Burlington Design Advisory Board

DESIGN ADVISORY BOARD Tuesday April 12, 2022 3:00 PM

**ZP-21-810; 175-177 South Union Street (RH, Ward 6S) Njama Braasch /
Ruth Latshaw**

To: The Design Advisory Board
From: Mary O'Neil, AICP, Principal Planner
RE: ZP 21-810; 175-177 South Union Street
Date: April 12, 2022

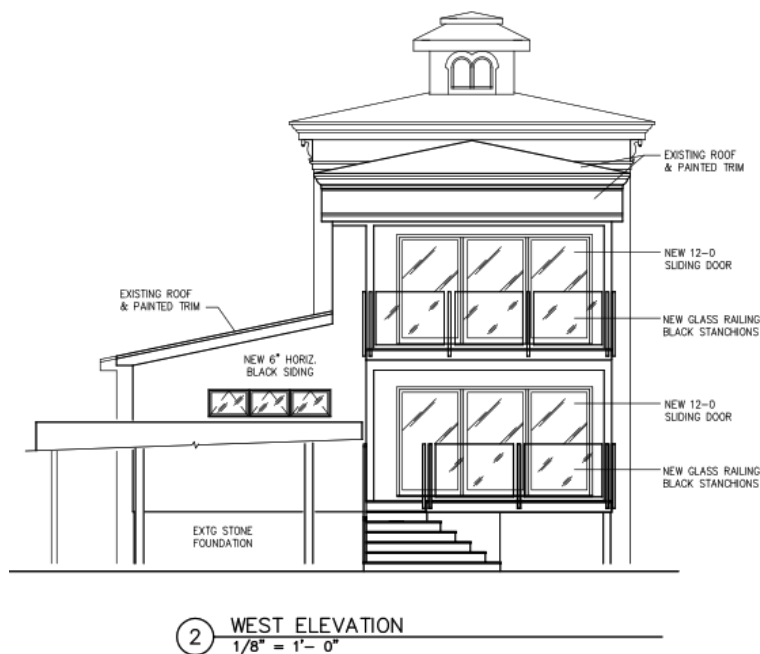
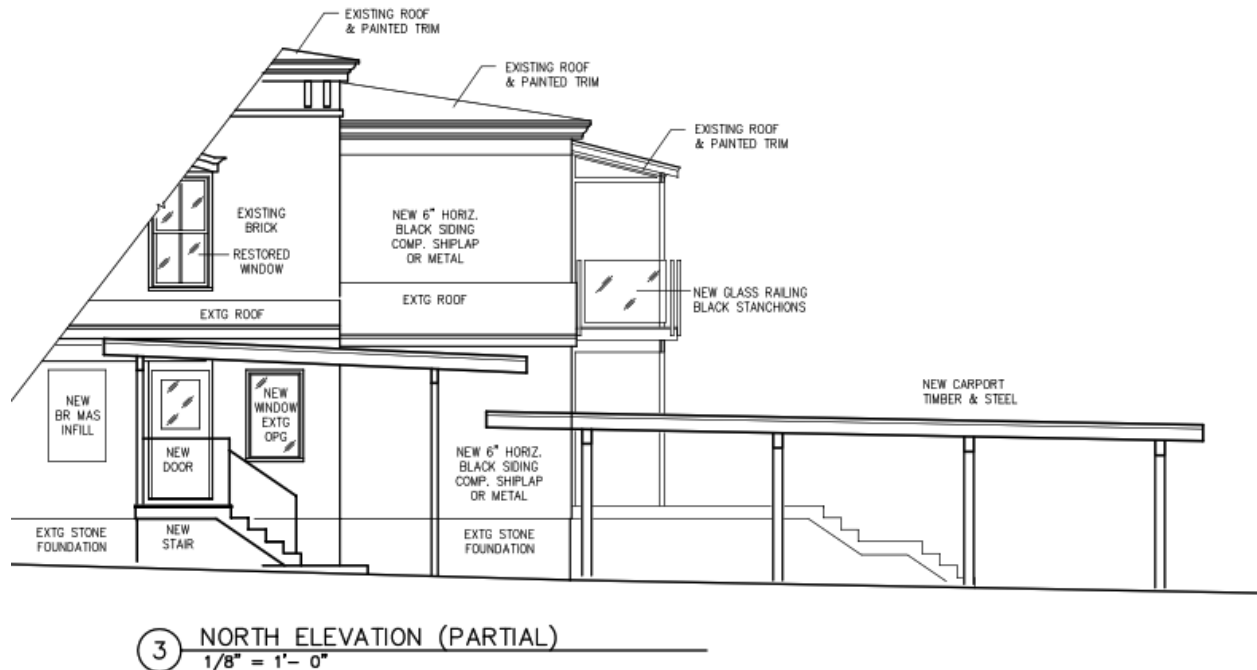
The massing, height and scale of the existing building is not proposed to be altered. Other than window, door and masonry repair, the majority of the work is isolated to the rear wing of the building and within the interior.

1 SOUTH ELEVATION (PARTIAL)
1/8" = 1'- 0"

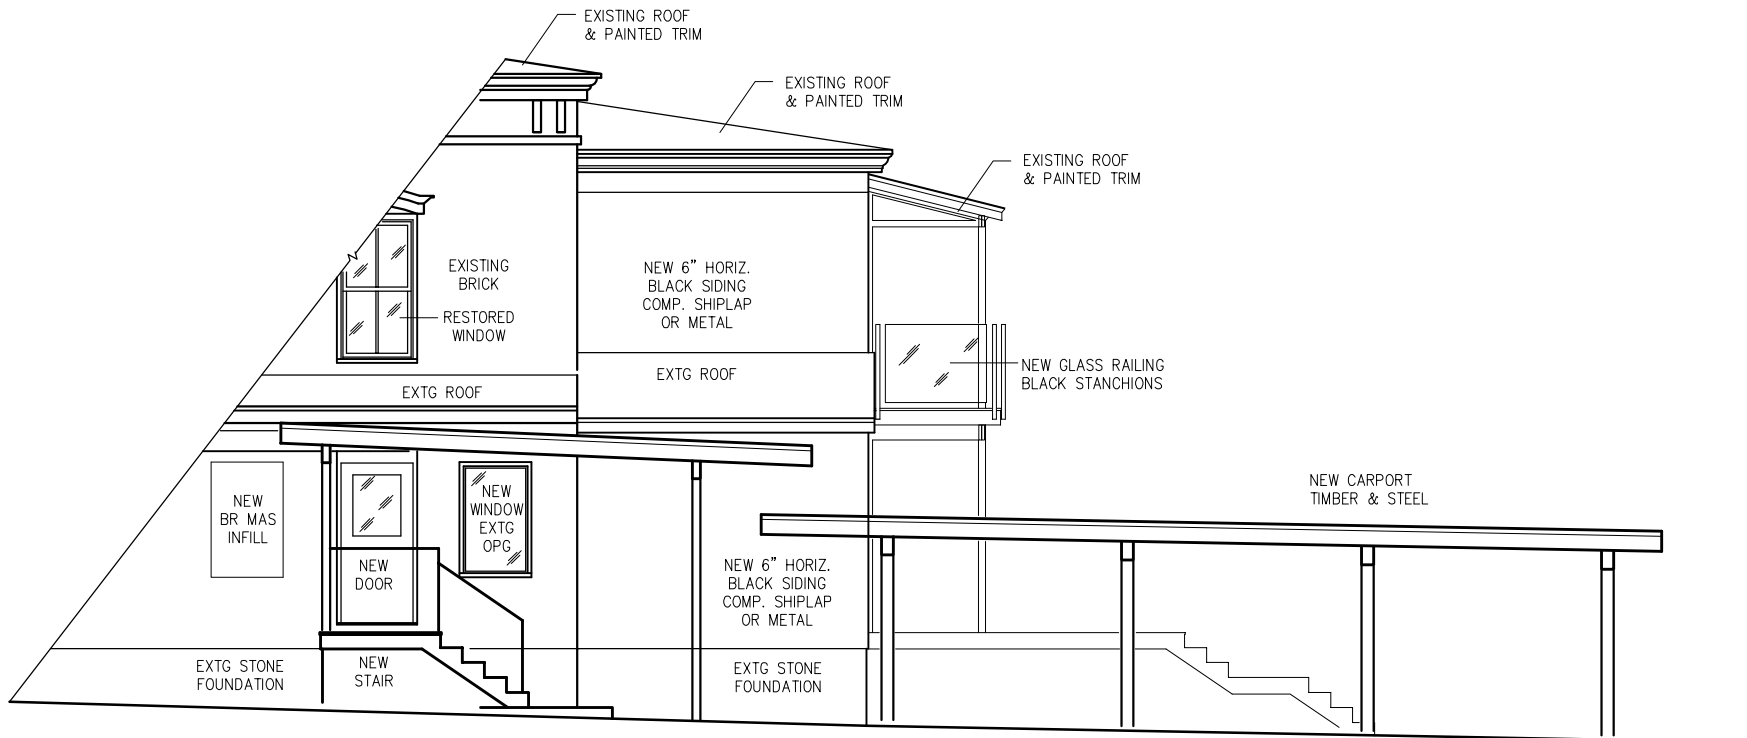
Changes proposed to the south elevation (Plan PIC5) will introduce a more modern engineered style of window to a historic masonry elevation that will immediately reflect conversations of the DAB Window review of March 29th. Ann Vivian includes the following proposal:

- a) The brick masonry on this side is in very poor condition and shows that window locations have been changed multiple times since initial construction. Some headers are cast iron in a plain style, others are soldier course brick. The long header or opening 1-14 is covered in wood and is likely compromised. The windows 1-13, 2-09, 2-10, and door and sidelight unit 1-14 sash and frames show significant warping with compromised operation or are inoperable. Door & sidelight 1-14 has rotted away at sill and window units 1-13 and 2-09 show significant fire and fire-fighting damage. Additionally, this side of the structure is only briefly visible between two buildings from King St. travel.

- b) Proposed scope of work:
Remove these four units, salvage sound cast iron headers, accomplish stone and brick masonry repair and rebuild, re-install historic salvaged cast iron headers from this building and elsewhere, frame new true openings and install new thin profile aluminum clad wood awning units and a double French door within exterior trims similar to original.

1. Simulated divided lights added to south facing windows in the historic block;
2. The chimney on the south ell of the main façade shall be retained.
